**R A D I O C A T**  
Centers For The Treatment Of Feline Hyperthyroidism

June 20, 2025

RE: RADIOCAT, LLC, LICENSE NUMBER 45-25330-01  
REQUEST FOR ADDITIONAL INFORMATION, MAIL CONTROL NO. 625737

Figure 1

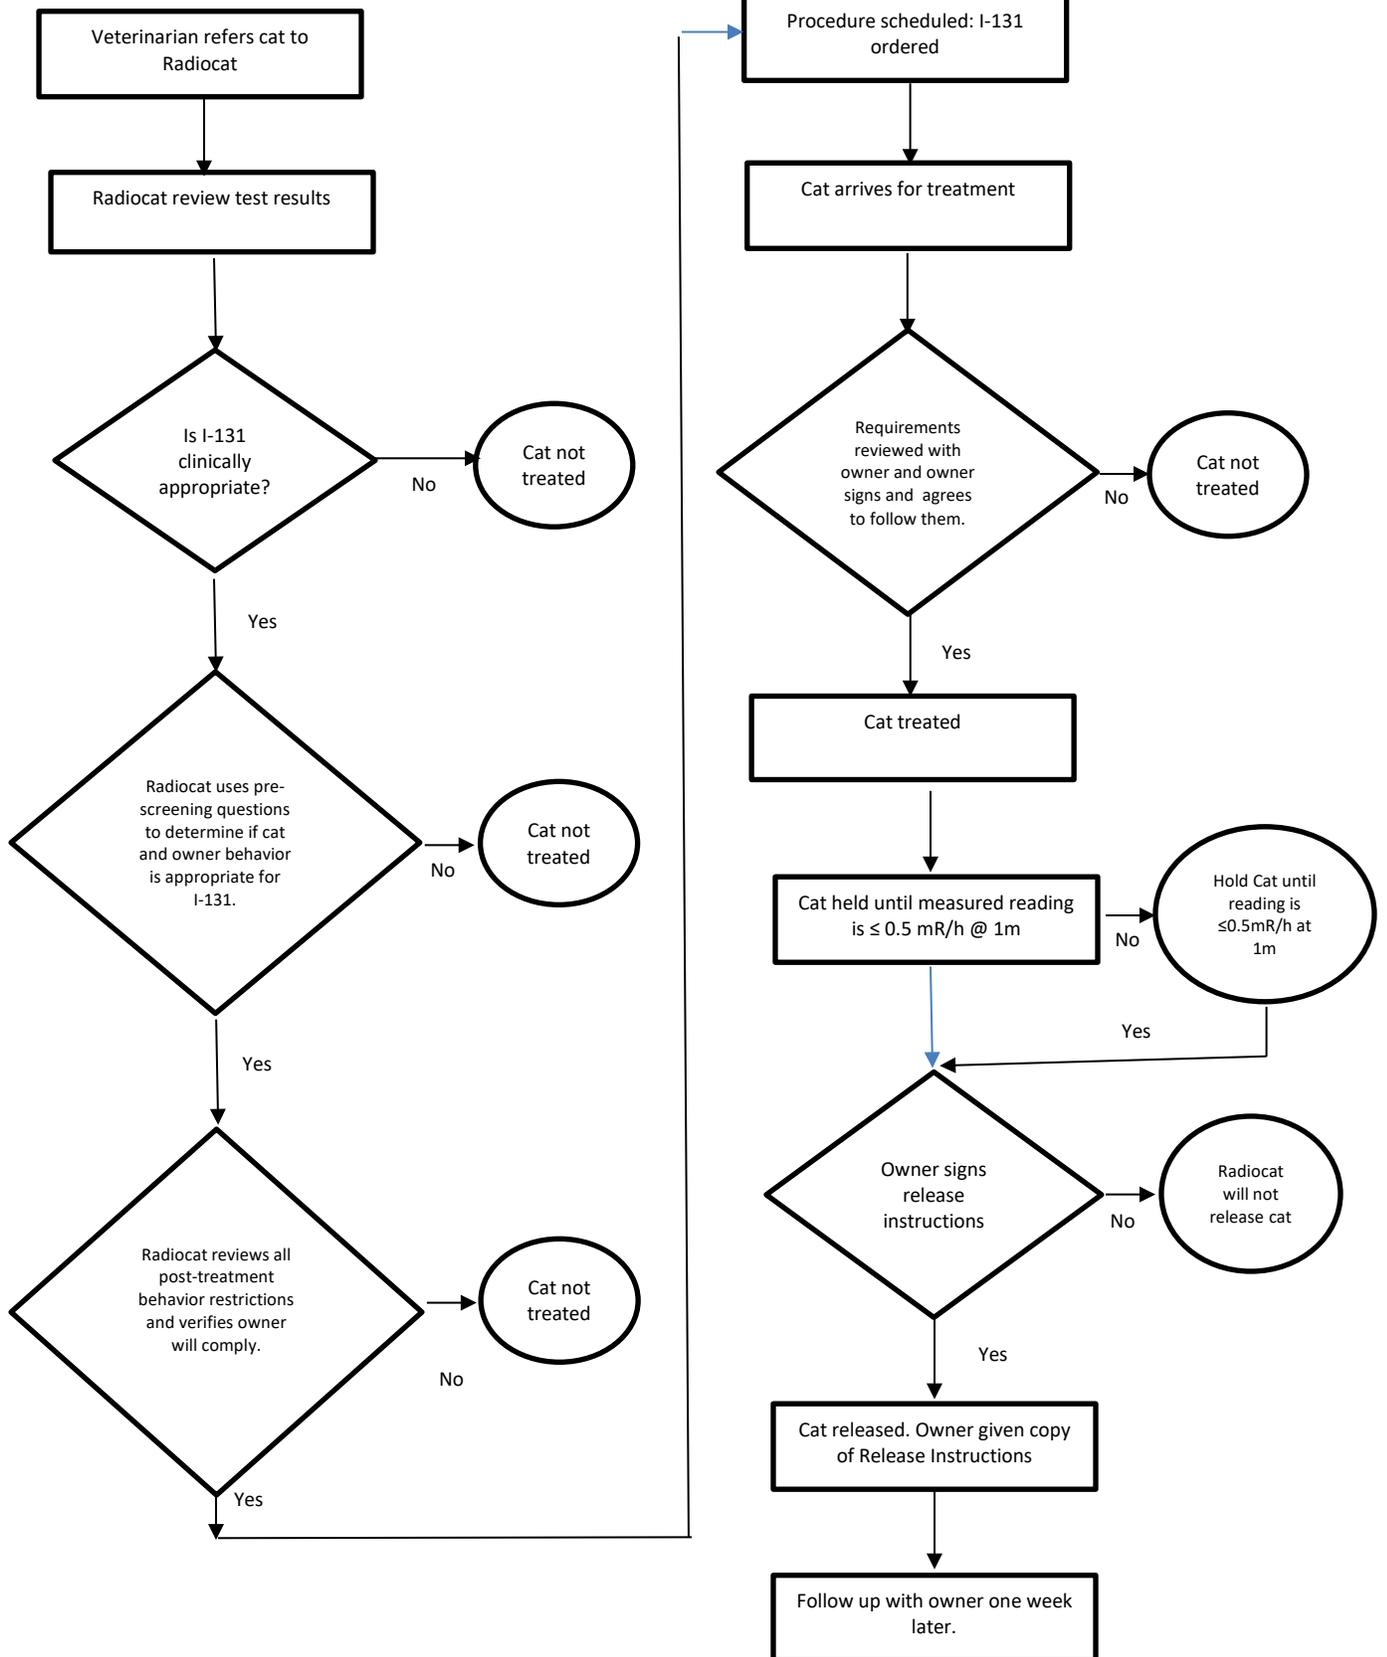
4. Your response dated March 21, 2024 contained a flow chart which indicates that Radiocat will follow up with the owner one week after the cat's release.

Please provide a copy of Radiocat's policy to follow up with the cat owner post treatment. The policy should include what types of questions will be asked and how compliance with the release instructions will be assessed.

Approximately one week after release, Radiocat will contact the owner of a patient and ask the following questions, some of which are open ended, and may lead to additional questions.

1. How is the patient doing.
  2. Is the patient eating, urinating, and defecating normally.
  3. Is compliance with safety instructions easy.
  4. If not, where are the problem areas. Describe in detail.
- If the owner indicates that the household has not complied with the written instructions, Radiocat will formulate corrective

actions for the household members to follow. If non-compliance could result in excessive dose, Radiocat will perform a dose assessment to determine the doses to individual household members.

5. Radiocat will explain the importance of following the instructions to minimize dose and protect the health and safety of individuals who may be in the patient's household. Radiocat will make recommendations on how to make safety instructions easier to follow. Radiocat will remind the owner of their signed commitment to follow specific procedures in the Release Instructions in the weeks after treatment.

If the initial attempt to contact the owner is not successful, the attempt will be repeated daily until contact is made. Radiocat will document the follow up efforts and contacts.
